**ADDENDUM No. 1**

**REQUEST FOR QUOTATIONS No.:** 1220-030-2022-023

**TITLE:** FLEETWOOD SKYTRAIN URBAN DESIGN STUDY

**ADDENDUM ISSUE DATE:** MAY 31, 2022

**2. REFER TO SCHEDULE A-1 FLEETWOOD PLAN STUDY AREA**

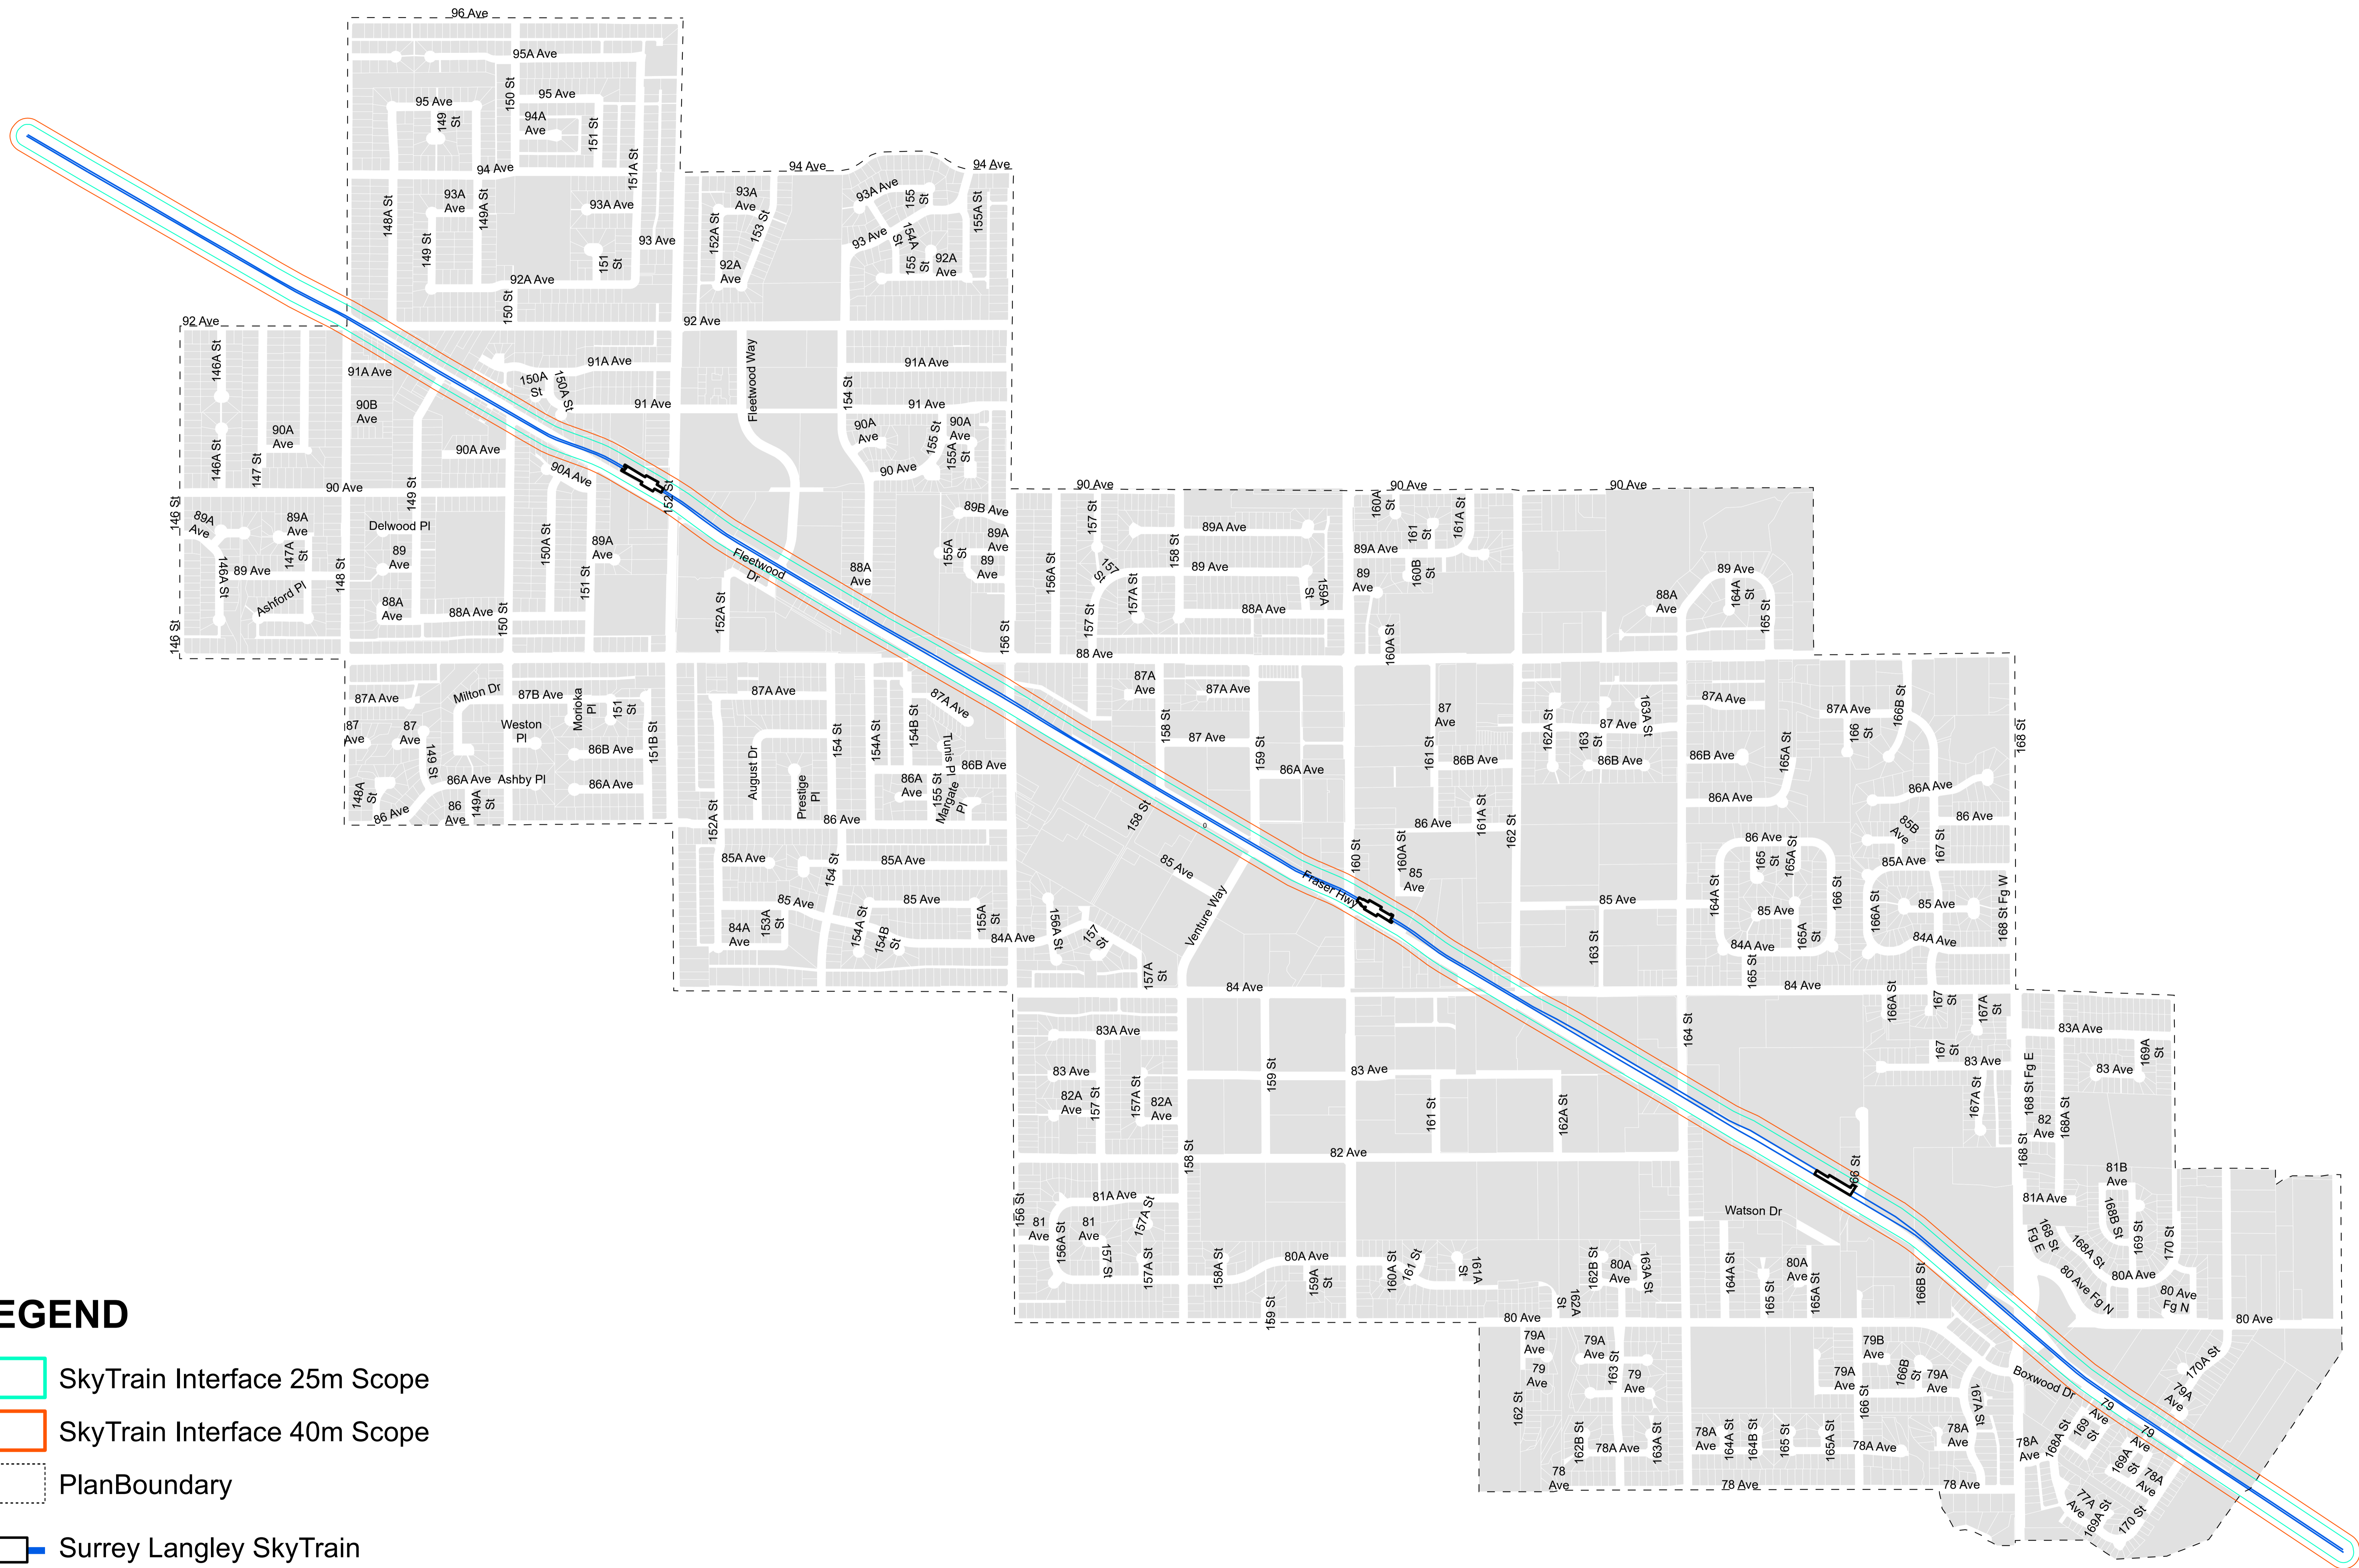
Please note that the conditions within the Study Area was loosely identified in order to develop the case studies to be examined as part of the scope of work.
